HSR Response to Morgan Hill Locally Generated Concepts:

The City of Morgan Hill has requested that the California High-Speed Rail (HSR) Authority respond to the following three locally generated concepts (LGCs) along Highway 101:

Figure 1: Typical HSR trench

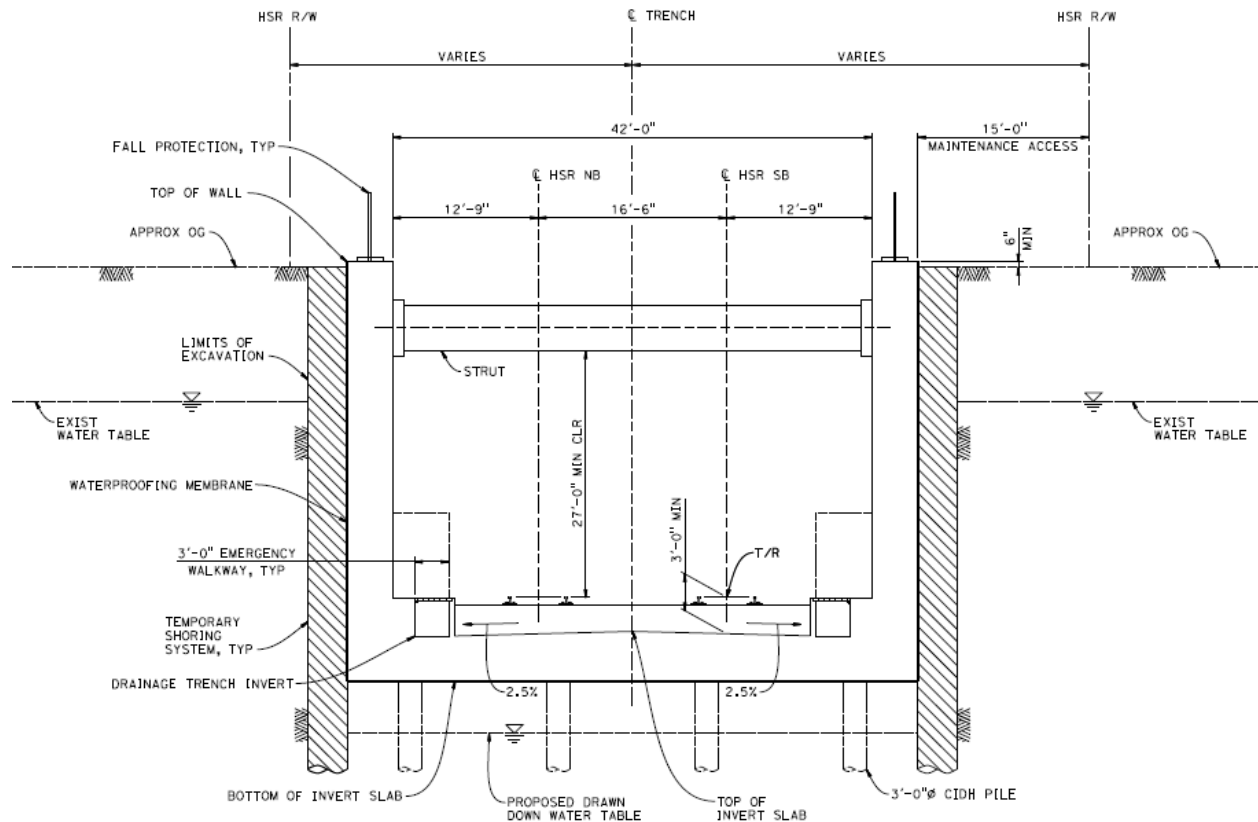
A trench along the west side of US101 in Morgan Hill would be comparable to the trench used in the previous east side US101 alignment alternative. The trench would need to be sufficiently wide to fit two HSR trains and emergency walkways, 42' internal clearance. The top-of-rail would be approximately 37' deep to support the 27' clearance envelope of the train and provide 10' of space for over crossing streets and utilities where needed. The external dimensions of the trench would be approximately 50' wide and 45' deep. Additionally, the trench would require a maintenance access road, 15' wide, adjacent to the western side of the trench. Overall the amount of ROW required by the trench would be 65' at a minimum, which is wider than the 58' need for a viaduct.

Previous geotechnical investigation data show the groundwater approximately 20' below ground at most places along the alignment, which is higher than the bottom of the trench. Due to the high ground water, the trench will need to be supported by temporary shoring during construction and then anchored with tension piles in the final condition. Therefore, cut-off walls would need to be installed on the outside of the trench walls, typically double the depth of the actual trench. The purpose of the cut-off-wall is to control groundwater intrusion in to an excavation, to minimize the requirement for dewatering. The ground water table around the outside of the trench remains at the same place due to the cutoff walls and the ground water table below the trench is lowered during construction.

Trenches built in high groundwater areas also require friction piles to resist the uplift caused by hydrostatic forces. These are the four cast-in-drilled-hole (CIDH) piles shown in Figure 1. These piles are 3' in diameter and would be approximately 60' deep in the location. Concrete struts are also be used to support the top of the walls and to resist seismic loading during an earthquake.

Figure 2: Standard Trench Cross Section

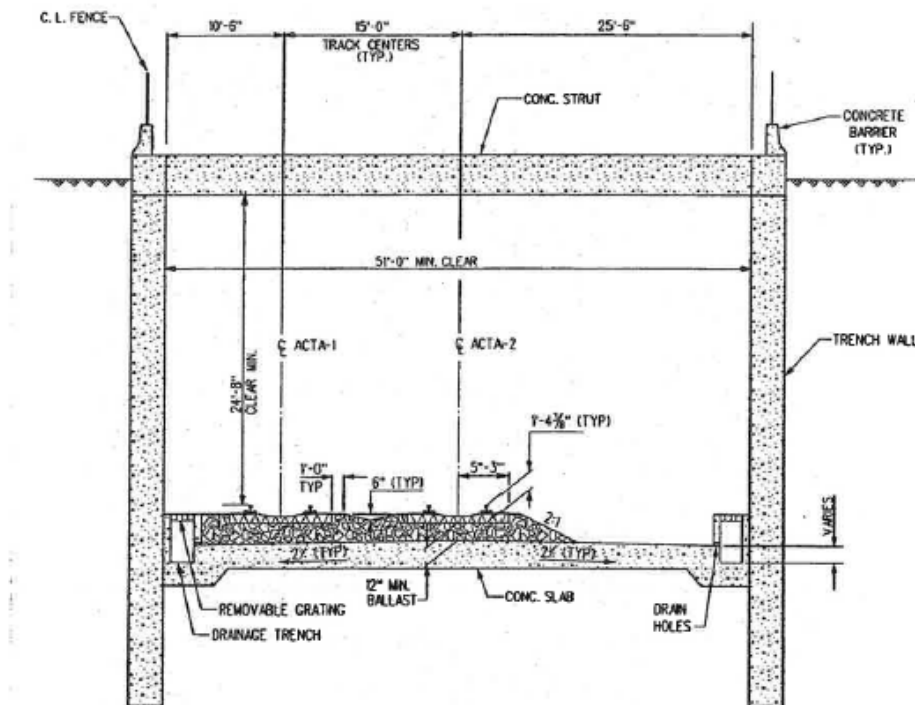
The Alameda Corridor Trench is not comparable to the type of trench needed for Morgan Hill, due to different soil and ground water conditions. The walls of the trench were constructed using secant piles, formed by installing a series of secondary piles overlapping primary piles. After both sides of the trench wall are constructed, the body of the trench may be excavated out and a cast-in-place invert slab is installed at the bottom of the trench. Please refer to Figure 2, which was taken from a white paper written by the designers of the Alameda Corridor Trench from PTG and HNTB in July 2000.

Judging from the depth of the trench walls, this was not an area of high ground water. There was also no need to use friction piles to hold down the trench, as would be required around the Morgan Hill area. Secant pile construction is an efficient method of trench construction. They have better stiffness compared to sheet piles and can be installed in difficult ground conditions. However, it is HSR's policy not to use secant pile walls because the waterproofing is hard to achieve in the joints.

Figure 2: HSR Complex Structure over US-101 (Drawing taken from Caltrans Initial Study Report)

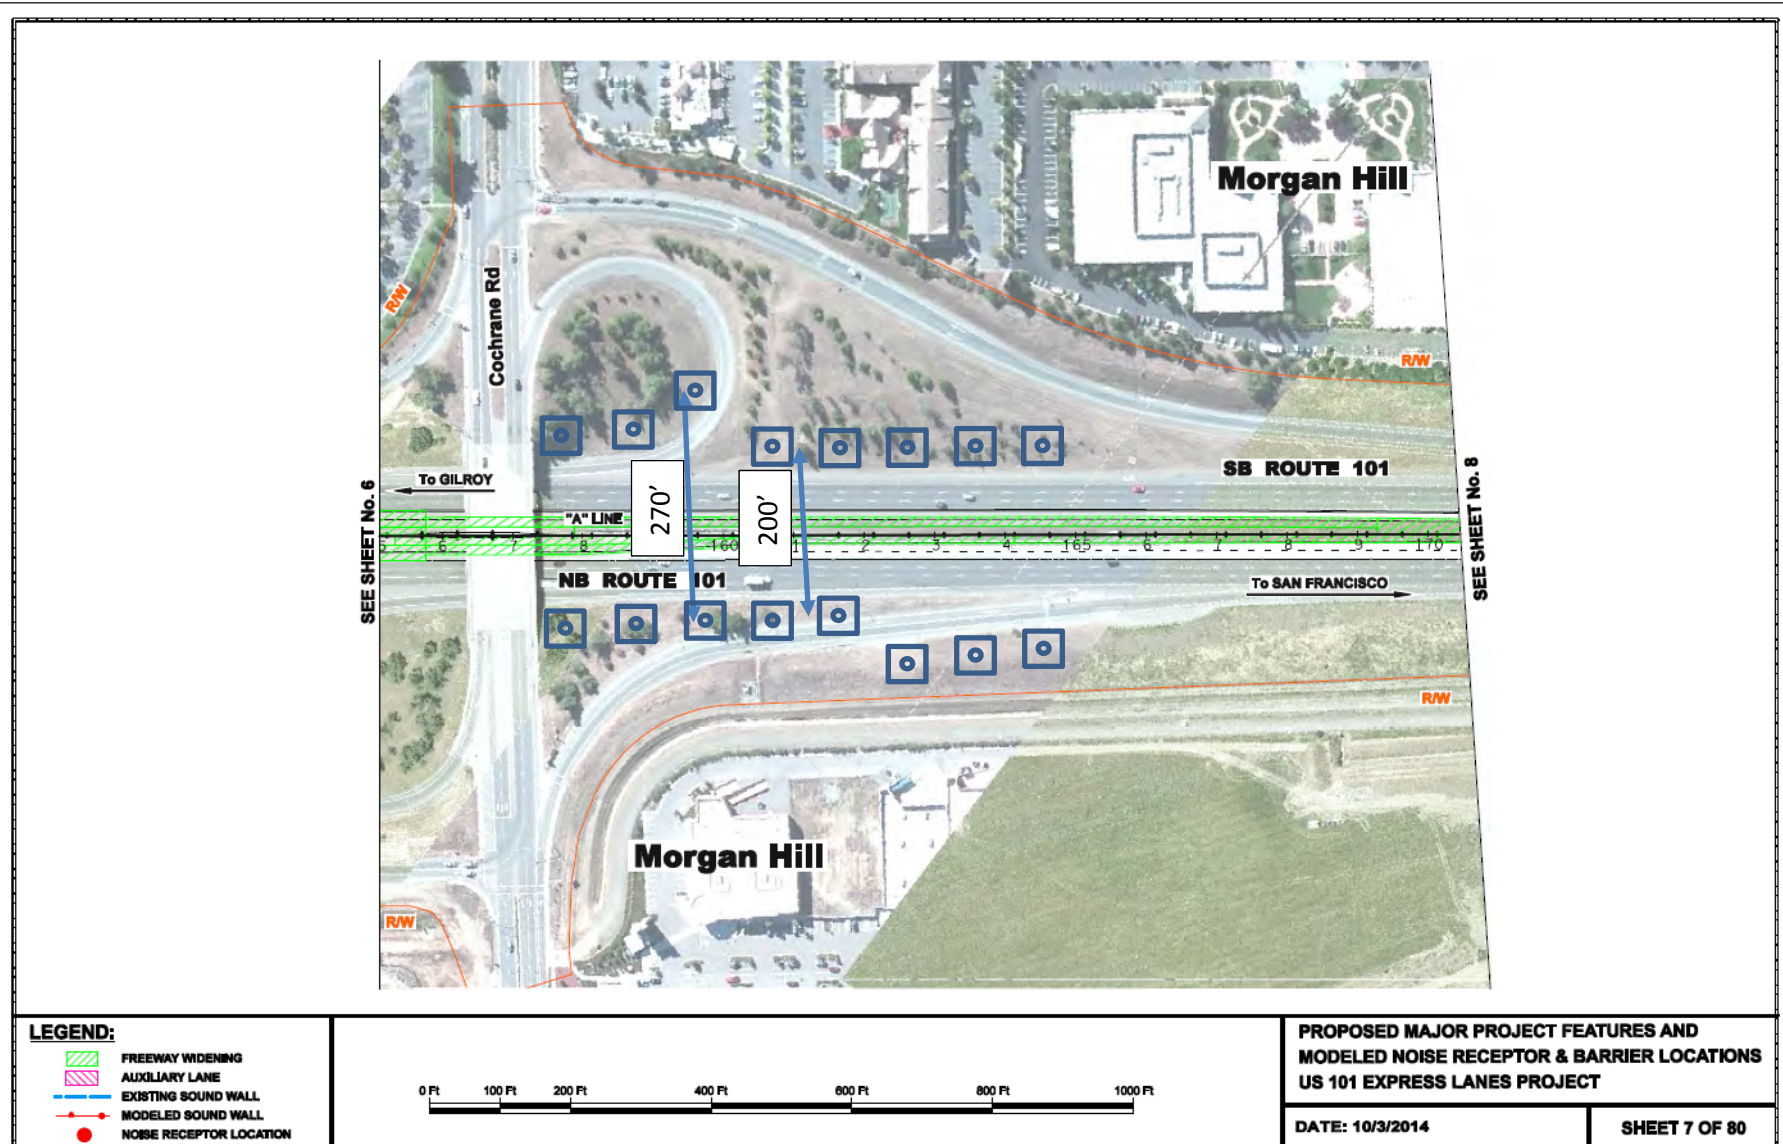
This alignment option involves constructing a pergola structure over US101, from Burnett Avenue to Tennant Avenue, approximately 4.5 miles. This area of US-101 has been identified in Caltrans' Route Concept Report for HOV expansion lanes in the median. Therefore, the columns of the pergola must be placed on the outside edges of the freeway and the deck must span 200'. At the interchange areas, the pergola must span up to 270' to allow room for the ramps. The transverse beams would have to be approximately 20' deep (10:1 length to depth ratio) to maintain the level of stiffness needed. Structures like this are not constructible nor cost effective.

To create a structure like this, casting yards would be needed to precast the large 200' x 20' girders. However, a very large crane would be needed to lift the girder into place. Cranes like this simply do not exist. The typical concrete girder for HSR is 110' long for that reason.

Alternatively, the contractor could also construct the girders using falsework and formwork. The pergola construction method would require multiple freeway lane closures to install the girders over the freeway traffic. The deck will be a mix of solid platform and horizontal beams, so different construction methods will be expected. The transverse girders would need to be precast on site and then installed by crane. The contractor must build falsework over the freeway to allow for installation of the bridge deck. The construction of the falsework would require temporary closures and detouring of traffic. Due to expected limitations on closures, it is expected that the overall duration of construction could be significantly longer than that of the viaduct construction. Caltrans would not allow the closure of their facility for such an extended period.

The complex structural supports needed to build the HSR alignment over US 101 would be very large and will not be feasible to construct, due to the amount of large girders spanning the freeway. Since the supports would need to be located outside the existing highway right-of-way, direct property impacts cannot be eliminated. The cost to construct is expected to be much greater than any potential savings in right-of-way, when compared to the existing viaduct alternative. Due to the constructability issues, added cost, and visual impacts, the Authority concludes that the Complex Structures over US101 concept would not be a feasible concept and further study is not warranted.

Figure 3: High-Speed Rail At-grade Typical Section

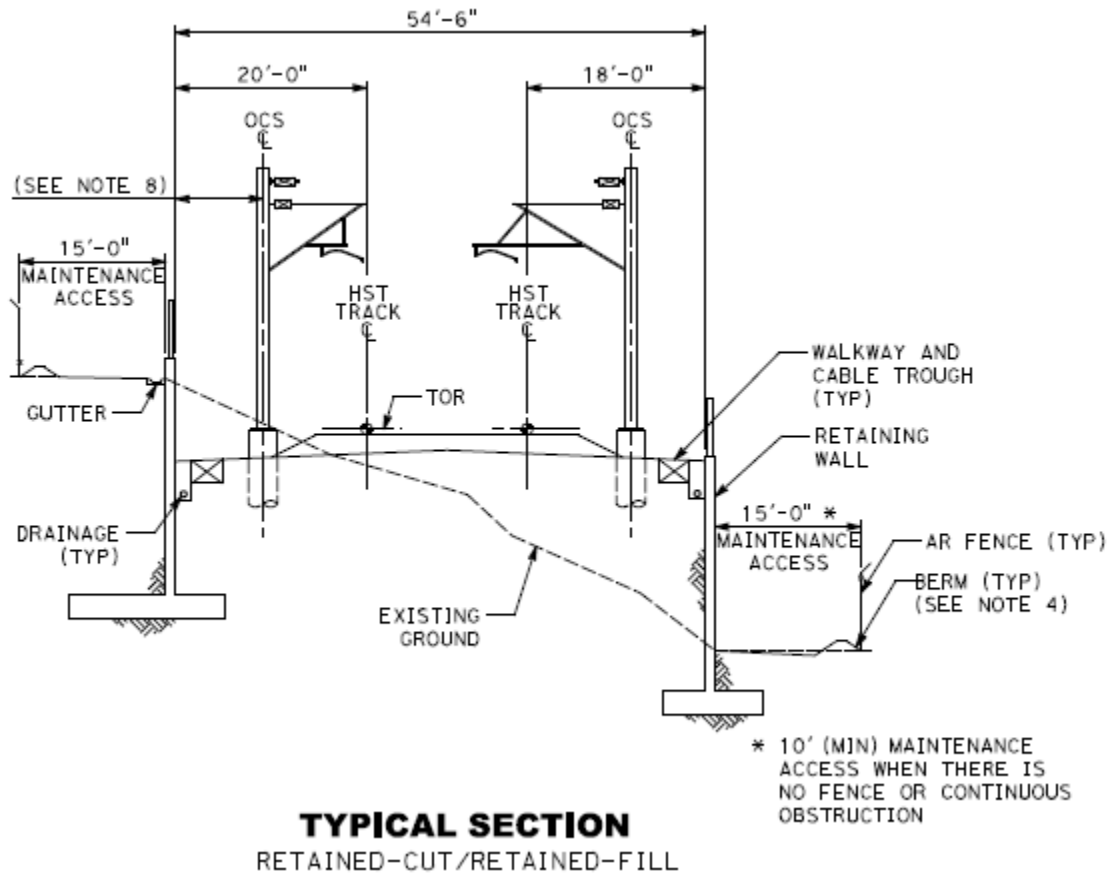
Furthermore, the median of US-101 varies between approximately 45' to 68' wide from edge of travelway to edge of travelway. A standard HSR at-grade cross section is 54'-6" + 10' minimum maintenance access road. The median is not wide enough for the entire length through Morgan Hill. South of Tenant, the HSR would have to slow down to speeds of approximately 90 mph, violating travel time mandates for the section.

An at-grade alignment in the median of US-101 is not constructible because of Caltrans' future express lanes project.
